ADDENDUM No. 1 to BID DOCUMENTS for

Cuyahoga Community College East Campus Food Service - Einstein Bagel Site Prep 4250 Richmond Road Highland Hills, OH 44122

June 17, 2019

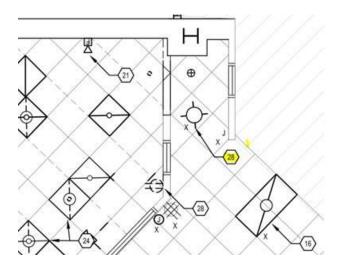
16. Sheet ED-101 Plan note #29 does not appear; please clarify?

GPD Response: Note 29 is meant for the downlight in the northeast corner it is currently designated 28 and is highlighted below for reference.
